STATE OF HAWAII
DEPARTMENT OF TRANSPORTATION
HIGHWAYS DIVISION

GRADING, DRAINAGE & CONSTRUCTION PLAN
FORT WEAVER ROAD
STA. 93+50.00 TO STA. 94+50.00
FORT WEAVER ROAD
SOUTH OF FARRINGTON HIGHWAY
TO THE VICINITY OF RENTON ROAD
SCALE: 1" = 50' DATE: SEPT 1979
SHEET NO. 1 OF 9 SHEETS

FORT WEAVER ROAD
SOUTH OF FARRINGTON HIGHWAY
TO THE VICINITY OF RENTON ROAD

GRADING, DRAINAGE & CONSTRUCTION PLAN
FORT WEAVER ROAD
STA. 158+50.00 TO STA. 172+25.00
FORT WEAVER ROAD
SOUTH OF FARRINGTON HIGHWAY
TO THE VICINITY OF RENTON ROAD
SCALE: 1" = 50' DATE: SEPT 1979
SHEET No. 7 OF 9 SHEETS

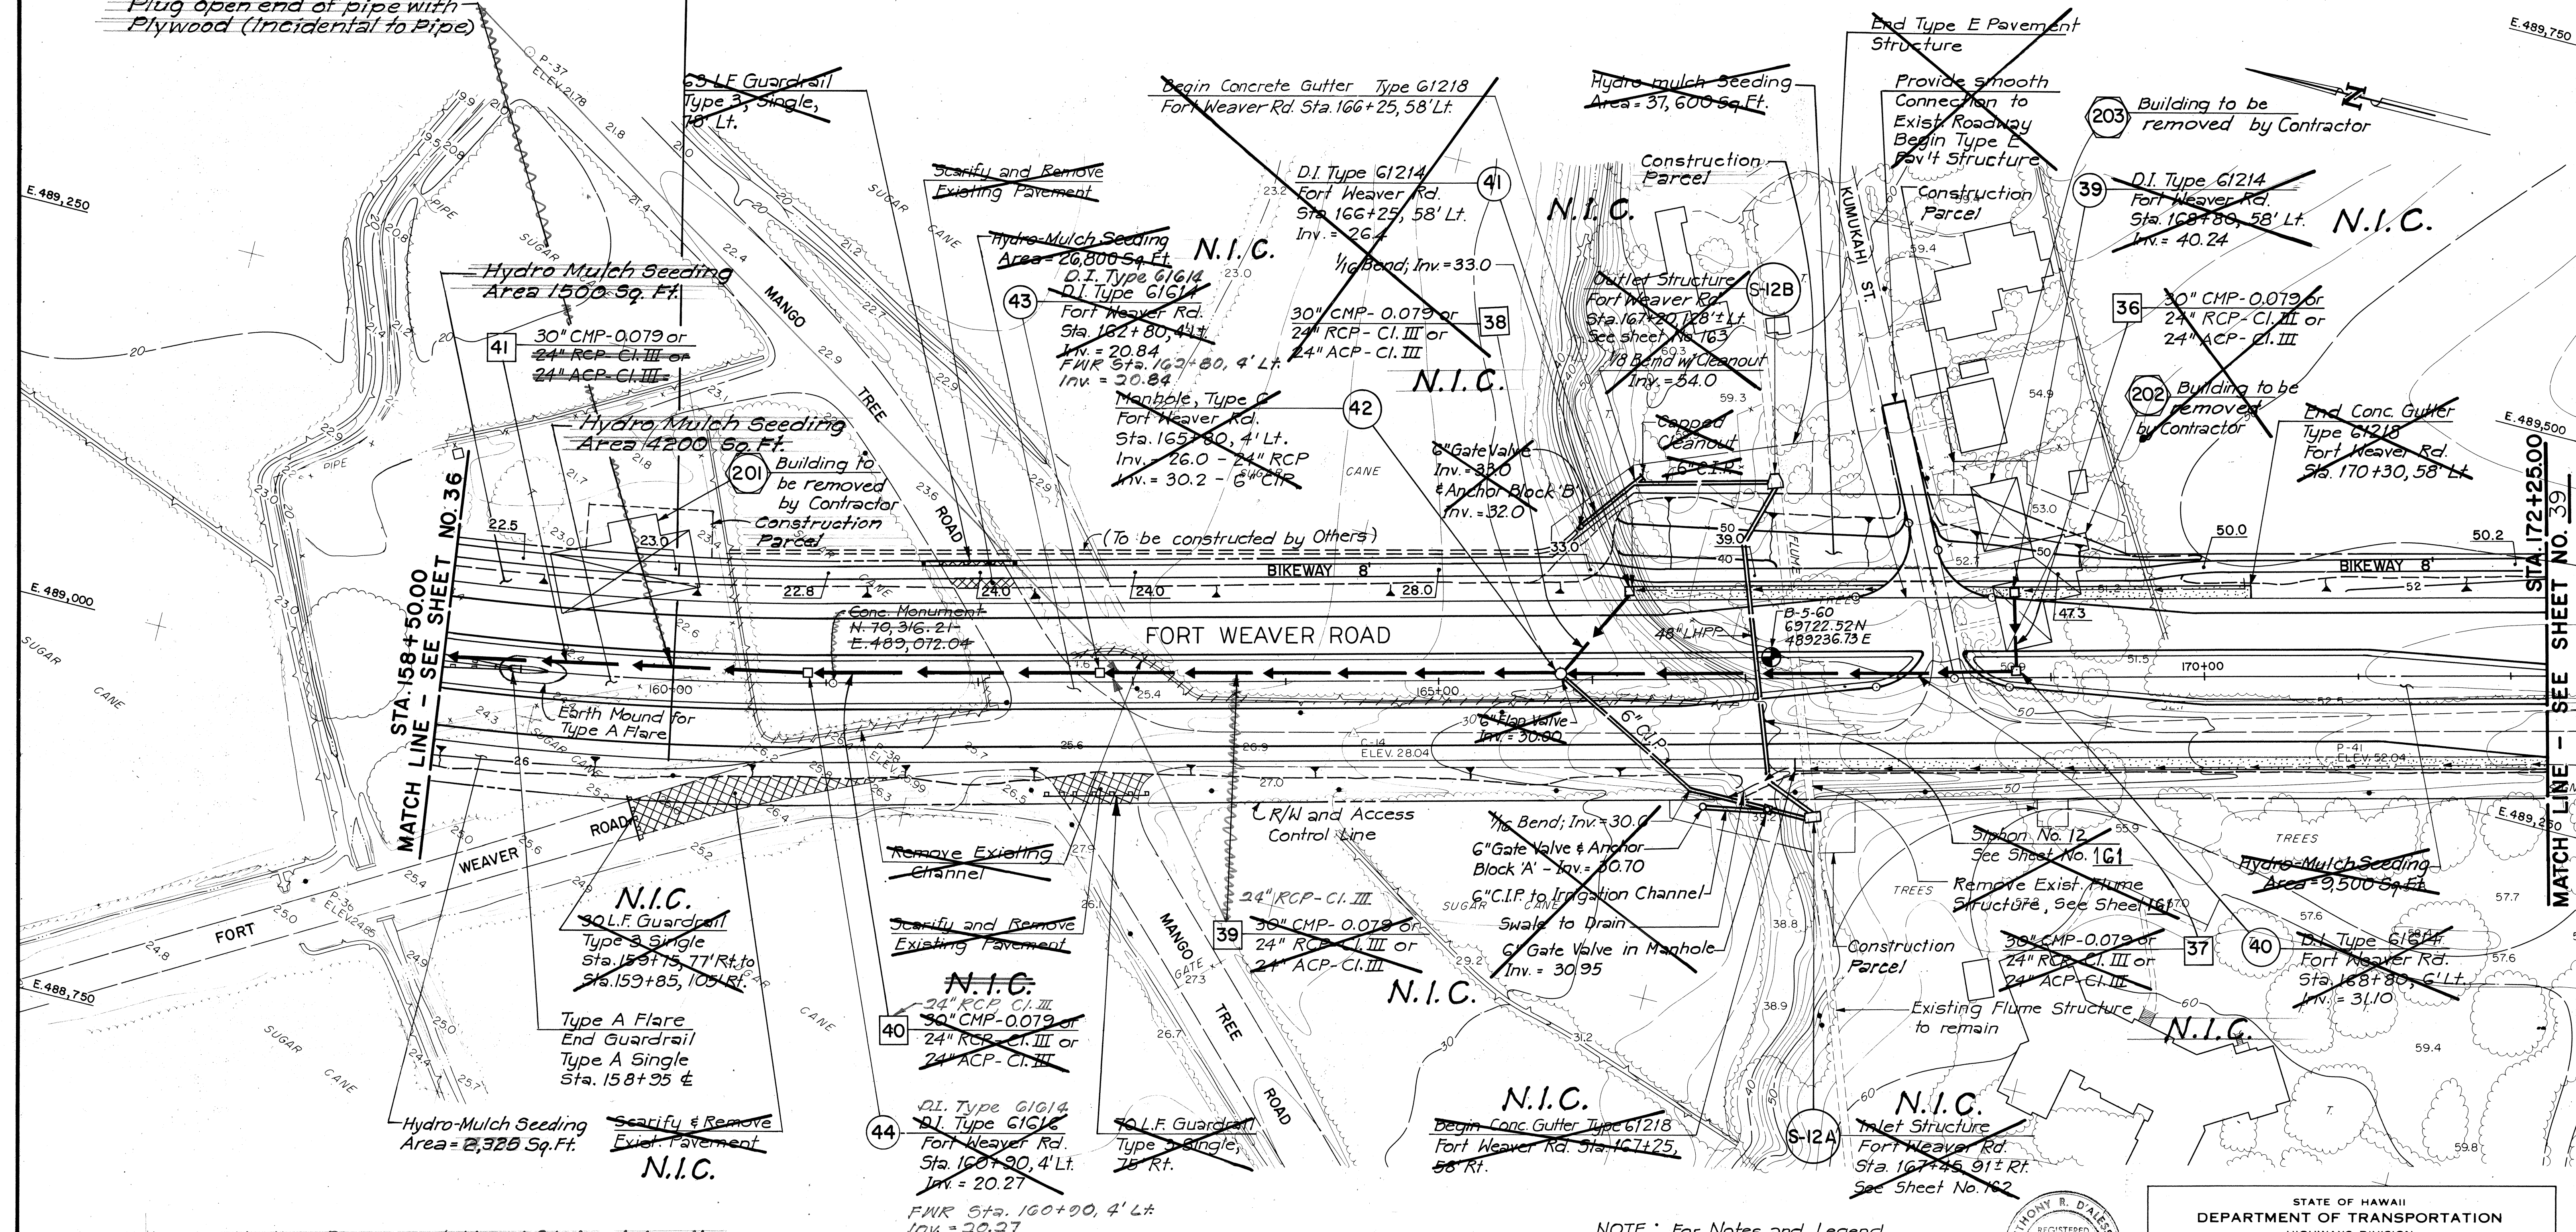
Install Drainline 41 on a Curved Alignment to Provide Clearance for the Light Standard at Sta. 158+75

Extended Median Drainage & Moved Stubout Location from Sta. 160+00 to Sta. 162+90. (Extension of drainage system was required when grading work was extended beyond original work limits.)

DATE	REVISION
11/7/80	Added New Construction Parcel at Sta. 160+00.
6/6/80	Demolition & Removal of Bldg. No. 203 to be part of Contract, per Addendum No. 1.
